Recommendation to make 17th St. two-way for bicycles next to the Marketplace

To the members of the Urban Design Committee,

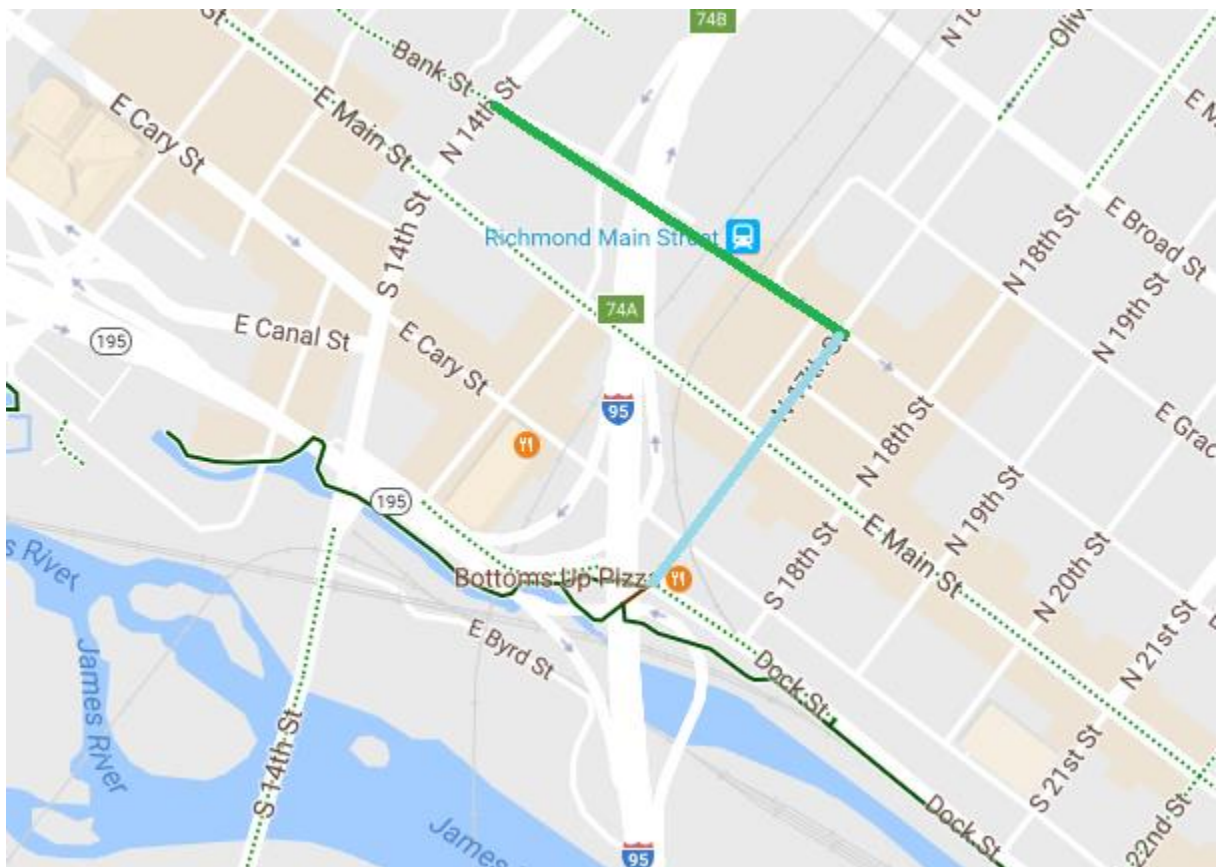
The under-construction, under-the-train shed bike lane is in light green, the Capital Trail in dark green, and the missing link in blue.

I have one small recommendation, which has no additional cost to the design but will help ensure seamless connectivity: making 17th St. two-way for bicycles here. As the brick pavers are only on the east side of the Marketplace, cyclists will choose to use that side for both northbound and southbound trips, rather than the highly uncomfortable granite spalls on the west side. This is just a fact of how the design is, and should be accommodated, not enforced against.

The total cost would just be adding two “Except Bikes” signs underneath the “Do Not Enter” signs, which would probably cost in the low tens of dollars. It would make legal what will be both the reality and the safest option for connecting from downtown to the Capital trail. And it is a solution already successfully used in the very same neighborhood.
